RS-19-018

Braidwood Stations, Units 1 and 2
Renewed Facility Operating License Nos. NPF-72 and NPF-77
NRC Docket Nos. STN 50-456 and 50-457

Byron Stations, Units 1 and 2
Renewed Facility Operating License Nos. NPF-37 and NPF-66
NRC Docket Nos. STN 50-454 and STN 50-455

Subject: Supplement to Application to Revise Braidwood Station and Byron Station
Technical Specifications to Adopt Risk Informed Completion Times
TSTF-505, Revision 2, "Provide Risk-Informed Extended Completion Times -
RITSTF Initiative 4b"

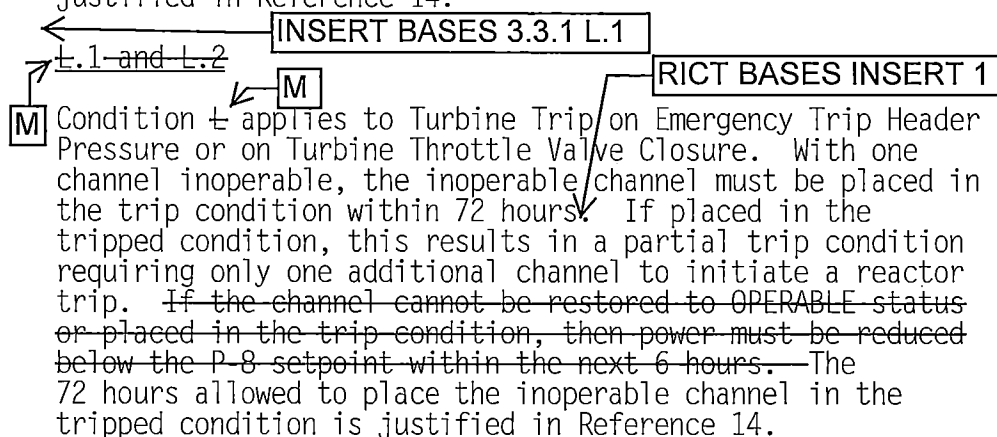
With one channel inoperable, the inoperable channel must be placed in the tripped condition within 72 hours. Placing the channel in the tripped condition results in a partial trip condition requiring only one additional channel to initiate a reactor trip above the P-7 setpoint. These Functions do not have to be OPERABLE below the P-7 setpoint. The 72 hours allowed to place the channel in the tripped condition is justified in Reference 14. ~~An additional 6 hours is allowed to reduce THERMAL POWER to below P-7 if the inoperable channel cannot be restored to OPERABLE status or placed in trip within the specified Completion Time.~~

Allowance of this time interval takes into consideration the redundant capability provided by the remaining redundant OPERABLE channel, and the low probability of occurrence of an event during this period that may require the protection afforded by the Functions associated with Condition K.

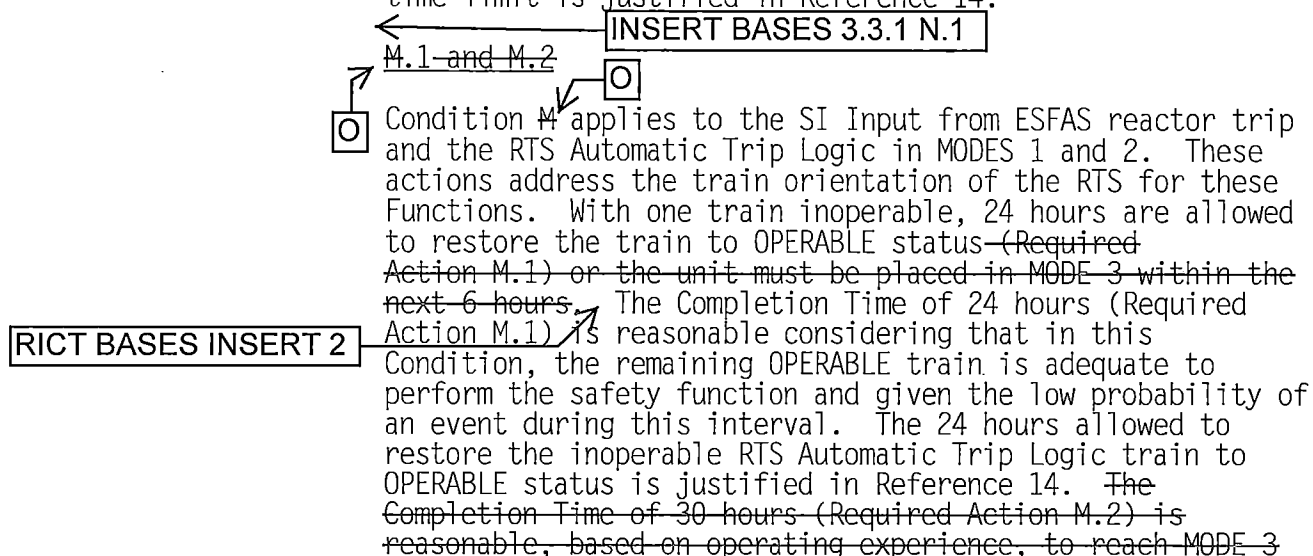
service or bypassed. If the surveillance time exceeds 12 hours, the Required Action would have to be performed (e.g., place channel in trip within 72 hours ~~or be in Mode 3 within 78 hours.~~) In addition, for channels with installed bypass test capability, if a channel is discovered inoperable, the bypass test capability could be utilized during troubleshooting prior to expiration of the appropriate TS Condition Required Action Completion Time to place the channel in trip. The 12 hour time limit is justified in Reference 14.

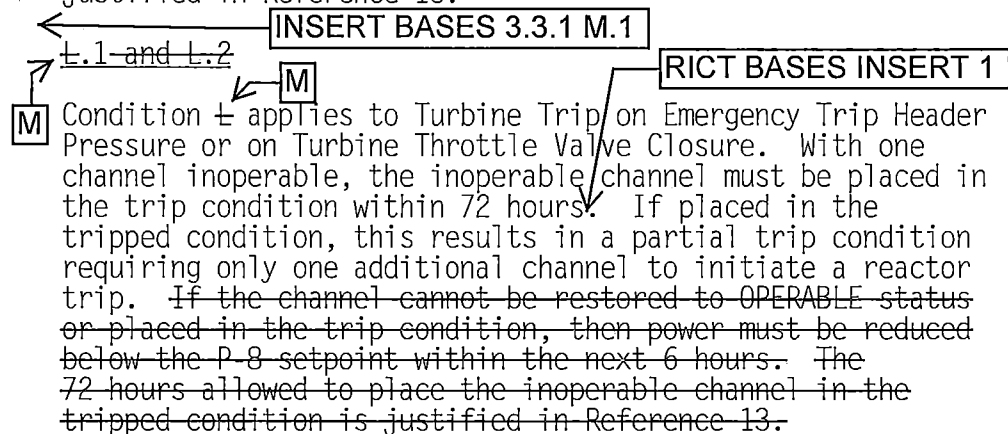
With one channel inoperable, the inoperable channel must be placed in the tripped condition within 72 hours. Placing the channel in the tripped condition results in a partial trip condition requiring only one additional channel to initiate a reactor trip above the P-7 setpoint. These Functions do not have to be OPERABLE below the P-7 setpoint. The 72 hours allowed to place the channel in the tripped condition is justified in Reference 13. ~~An additional 6 hours is allowed to reduce THERMAL POWER to below P-7 if the inoperable channel cannot be restored to OPERABLE status or placed in trip within the specified Completion Time.~~

Allowance of this time interval takes into consideration the redundant capability provided by the remaining redundant OPERABLE channel, and the low probability of occurrence of an event during this period that may require the protection afforded by the Functions associated with Condition K.

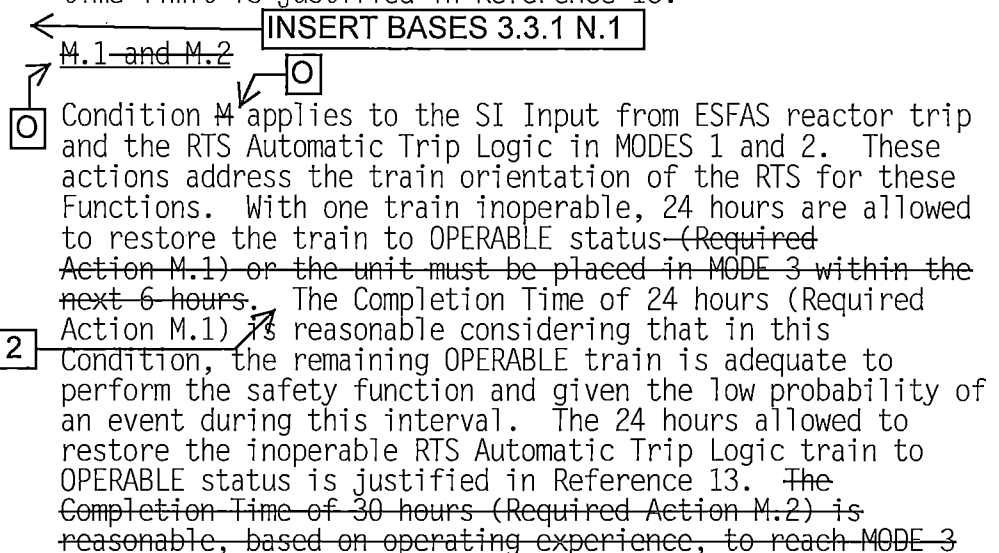
service or bypassed. If the surveillance time exceeds 12 hours, the Required Action would have to be performed (e.g., place channel in trip within 72 hours ~~or be in Mode 3 within 78 hours.~~) In addition, for channels with installed bypass test capability, if a channel is discovered inoperable, the bypass test capability could be utilized during troubleshooting prior to expiration of the appropriate TS Condition Required Action Completion Time to place the channel in trip. The 12 hour time limit is justified in Reference 13.

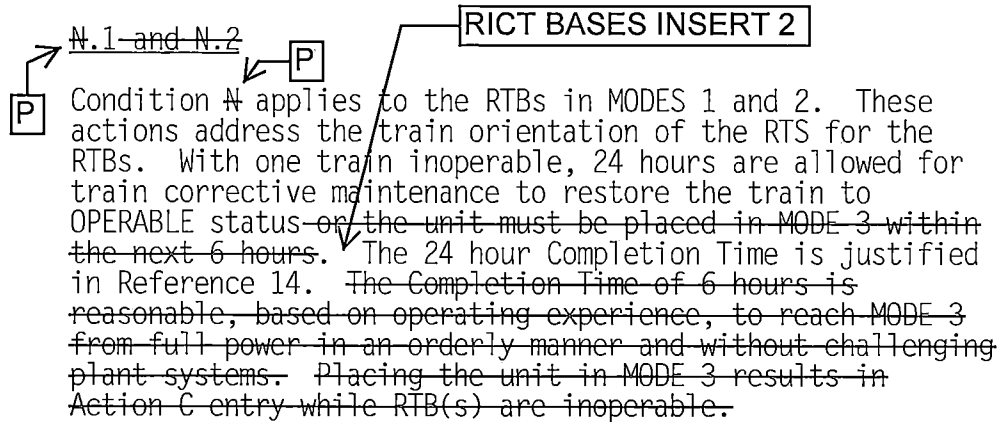
The Required Actions have been modified by a Note that allows bypassing one train up to 4 hours for surveillance testing, provided the other train is OPERABLE.

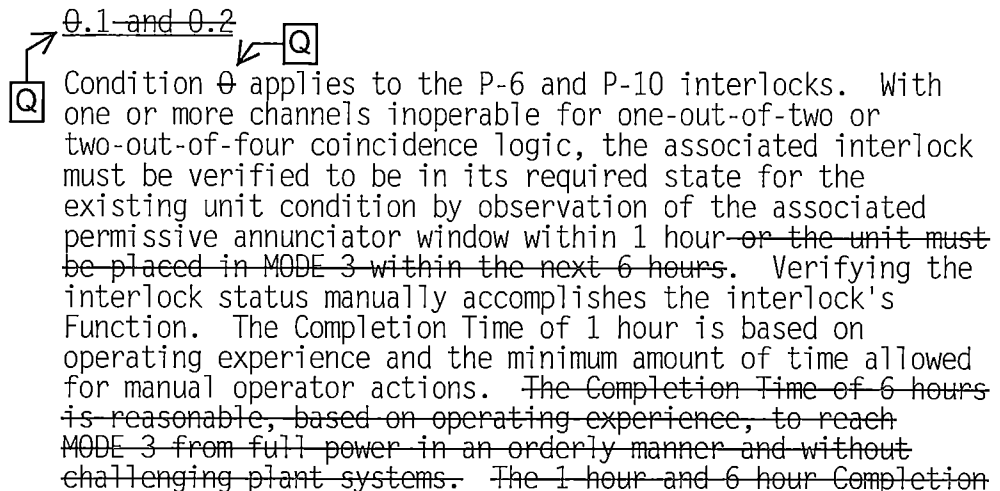
The 4 hour time limit for testing the RTS Automatic Trip Logic train may include testing the RTB also, if both the Logic test and the RTB test are conducted within the 4 hour time limit. The 4 hour time limit is justified in Reference 13.
